Serial No. 10/750,447

## Amendments to the Drawings:

Ser. No. 10/750,447 Reply to Office Action of 3/27/06 Annotated Sheet Showing Changes

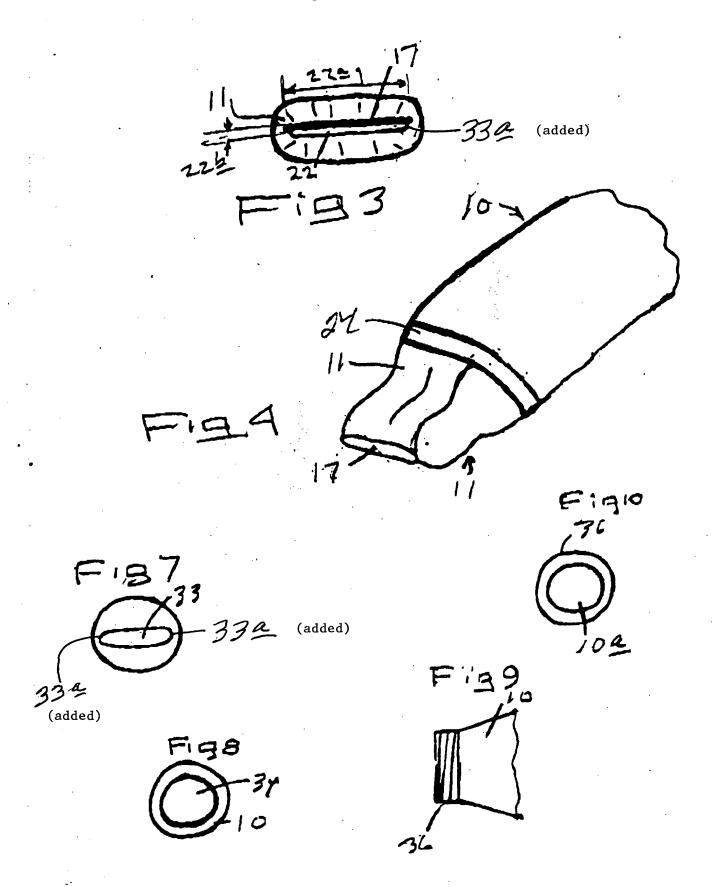
The attached sheet of drawings includes changes to Figs. 3 and 7. This sheet, which includes Figs. 3, 4, 7, 8, 9, and 10, replaces the original sheet including Figs. 3, 4, 7, 8, 9, and 10. In Figs. 3 and 7, previously omitted element 33a has been added.

In Figs. 5 and 6, the blade is now designated at

"17", instead of 34, to be consistent with Figs. 1-3. The arcuate and concave surfaces at widthwise opposite ends of the narrowed opening (i.e. exit) 33 are designated at 33a. See the wording of the specification at line 5, page 12. (See also Fig. 20.)
